Addendum # 1

Project Name: City of San Luis Union Street & 6th Ave. Paving Improvements
NEI Project Number: 017-0043
Date: 03/20/2018

6TH AVENUE DEMOLITION PLAN

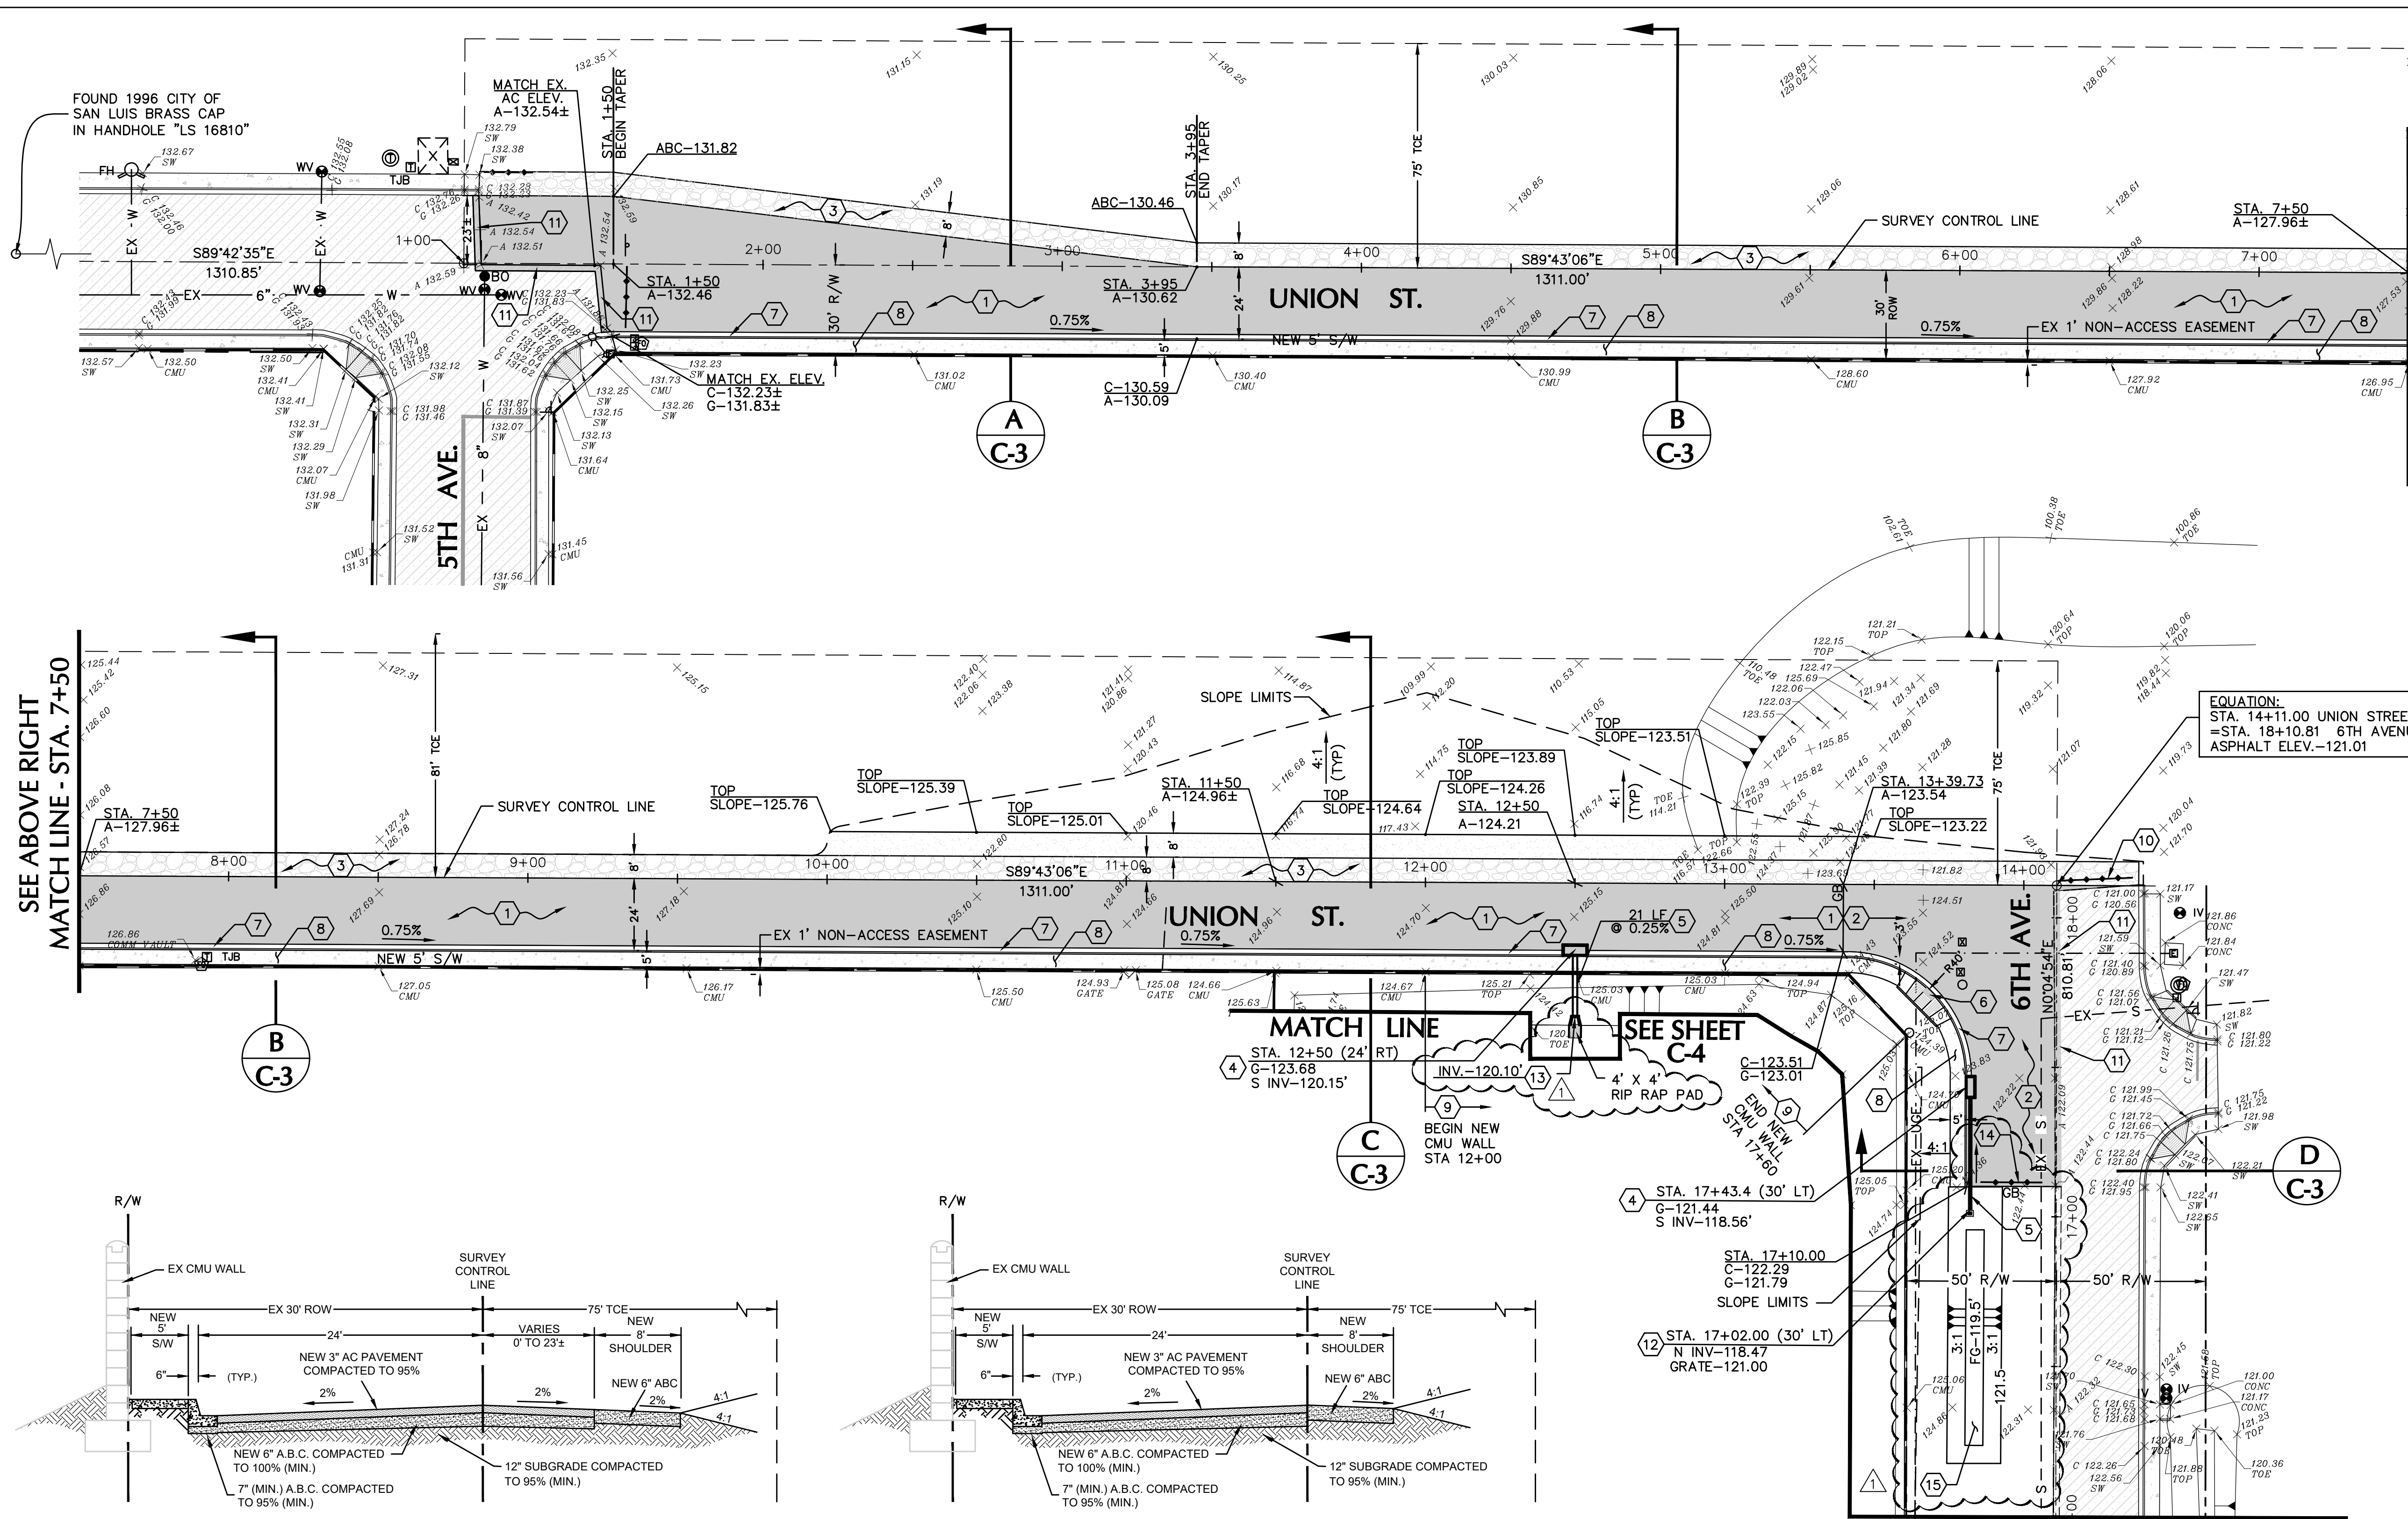
1. Replace the existing set of plans with the new set dated 3/20/18. The plans have been revised to remove the 6th Avenue widening, and all associated work from the base bid. The contractor will grade a temporary retention basin as shown on the new plans. The striping shall also be modified as shown on the updated striping plans.
2. The Bienestar Subdivision retention basin irrigation and excavation work has been removed from the scope of work as shown on the new plans dated 3/20/18.

THIS SHEET NOT A PART OF BASE BID

6TH AVENUE IMPROVEMENTS

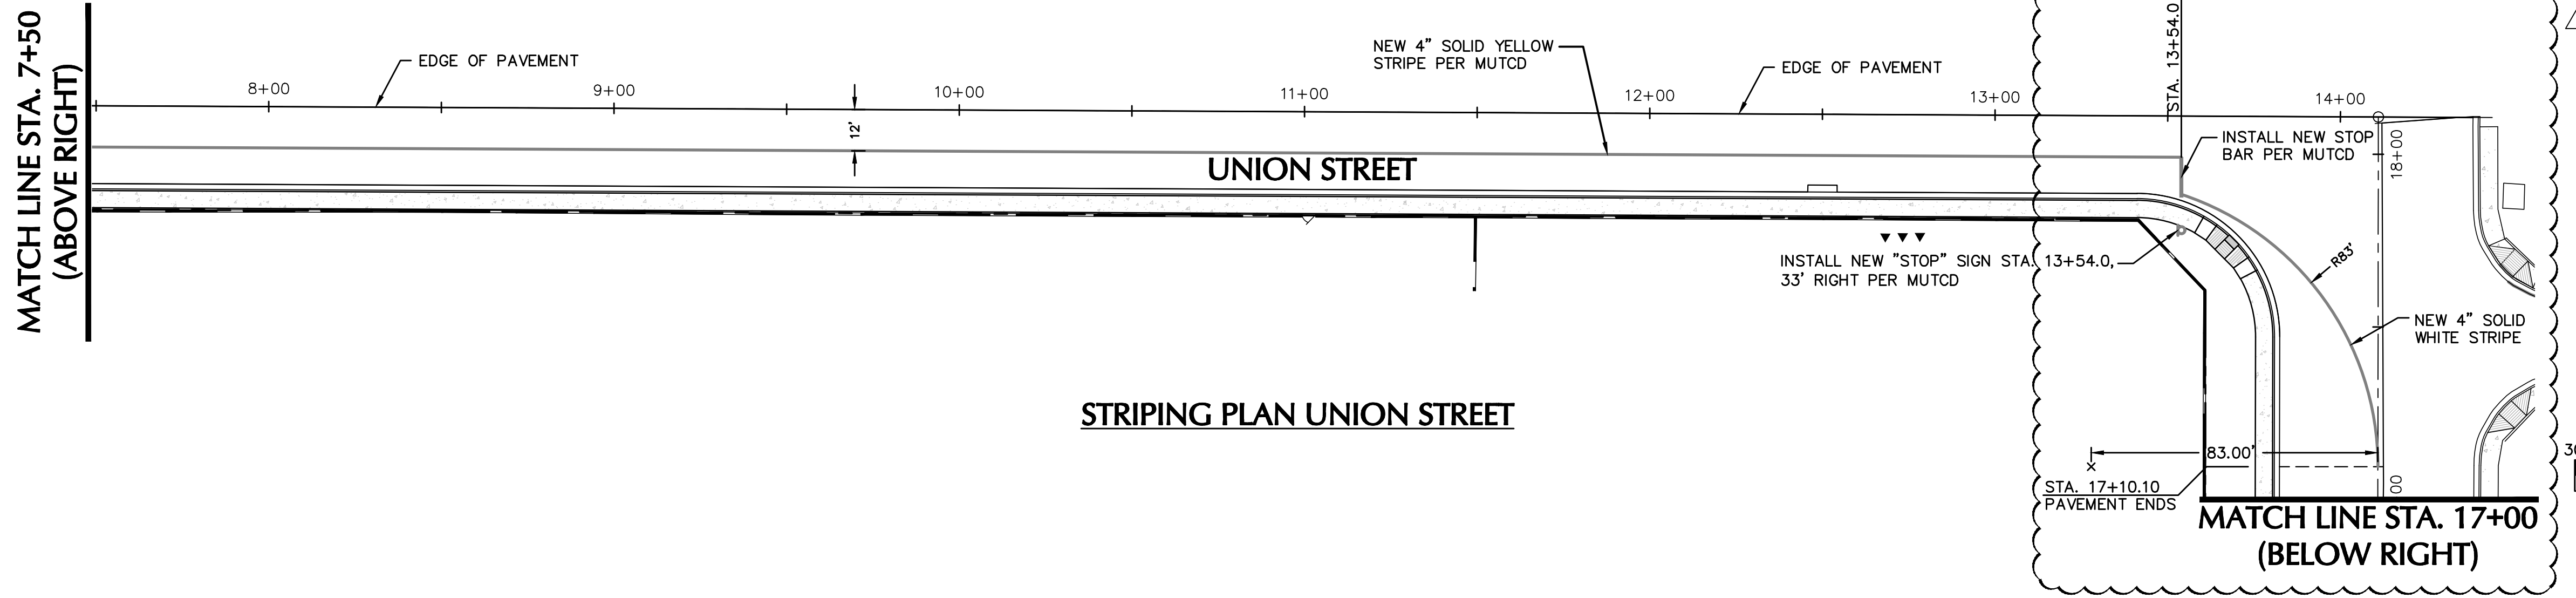
**THIS SHEET
NOT A PART OF
BASE BID**
